# 16jm Ad Hoc Group Recommendations on High Level Constructs for 16m Relay Frame Structure

IEEE C802.16m-08/499

For informing TGM about the discussions that took place in the 16jm AHG regarding frame structure constructs.

## Example UL Frame Structure for Case 8 (FDM)

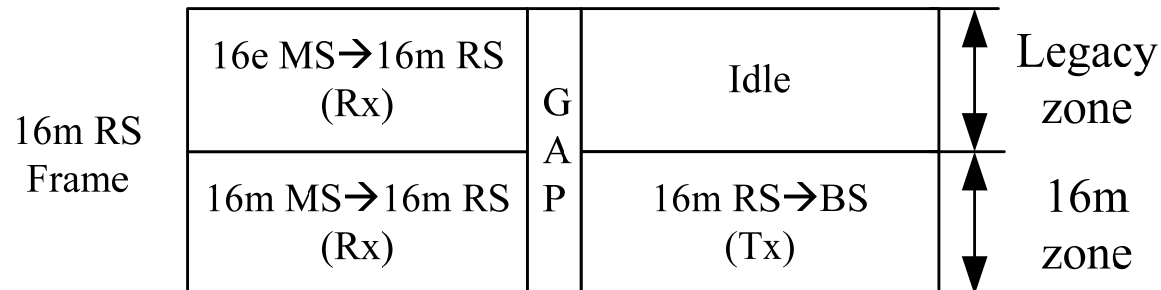
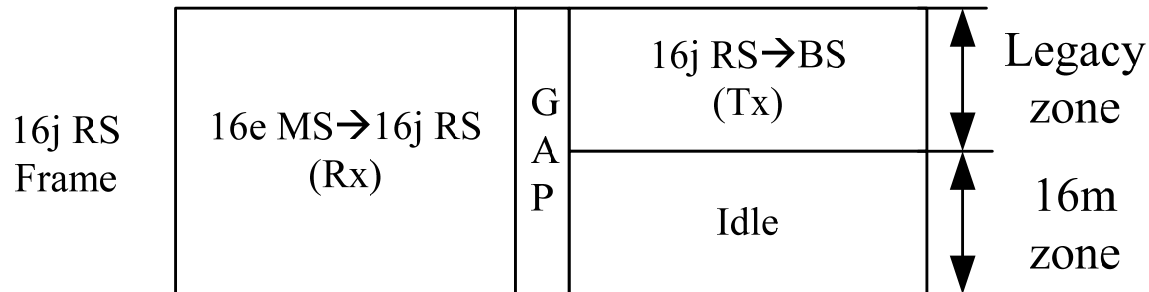
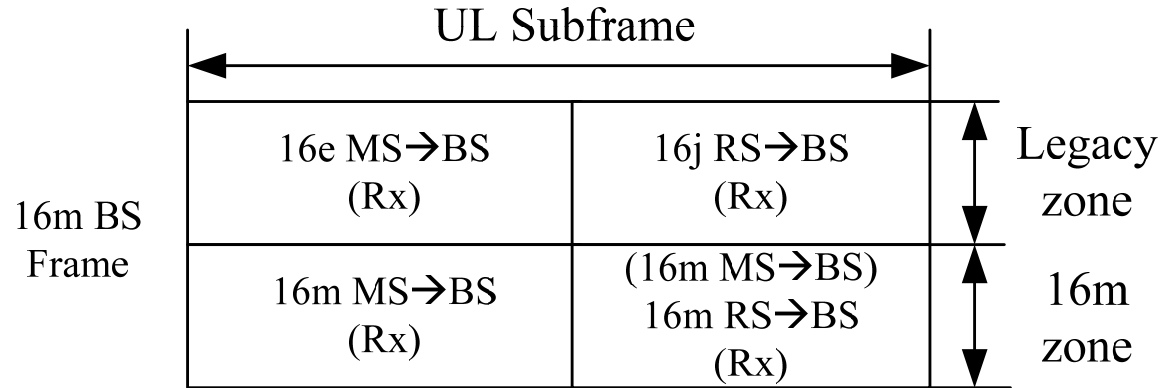
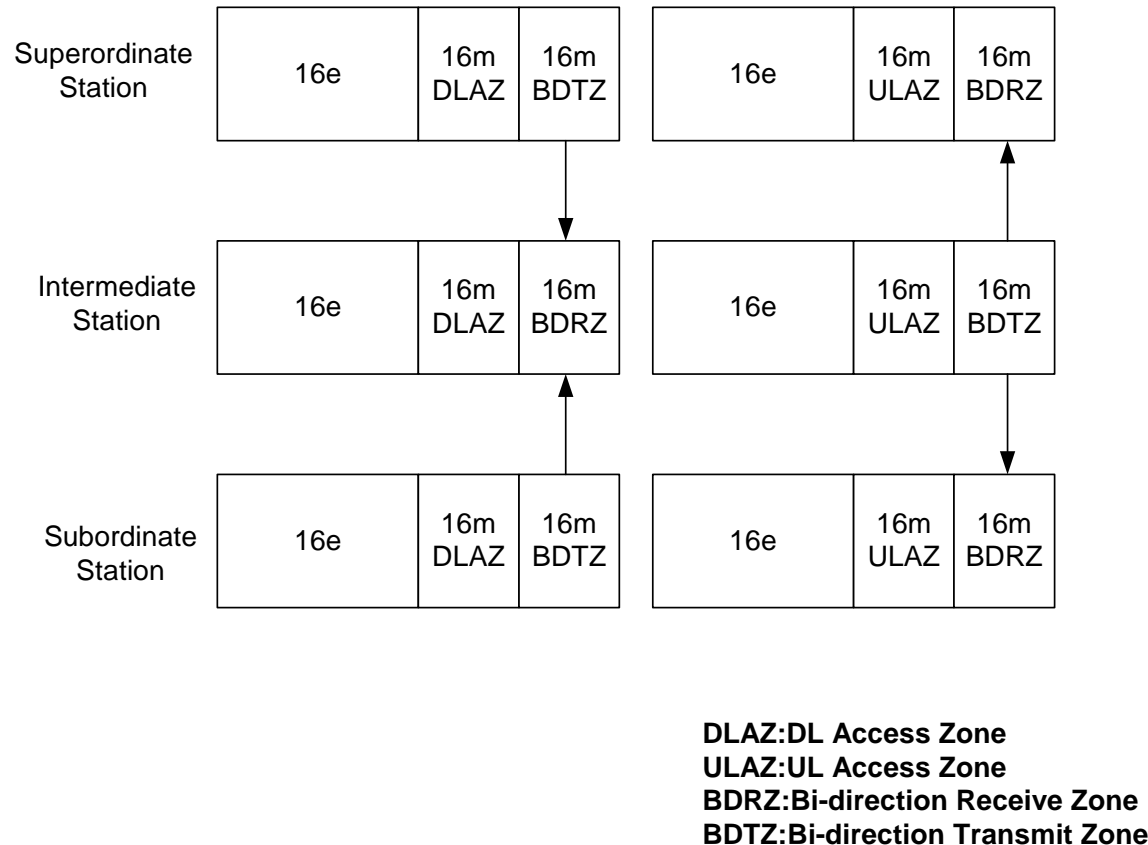
- Intel: Modify slide 15 according to decision on multiplexing of Legacy and 16m zones in the UL.
- Huawei: Alternative Illustration

- Defer discussion until decision on the basic constructs (Slides 6 through 11 of 16mRelayFS-AHG.pdf) can be made.
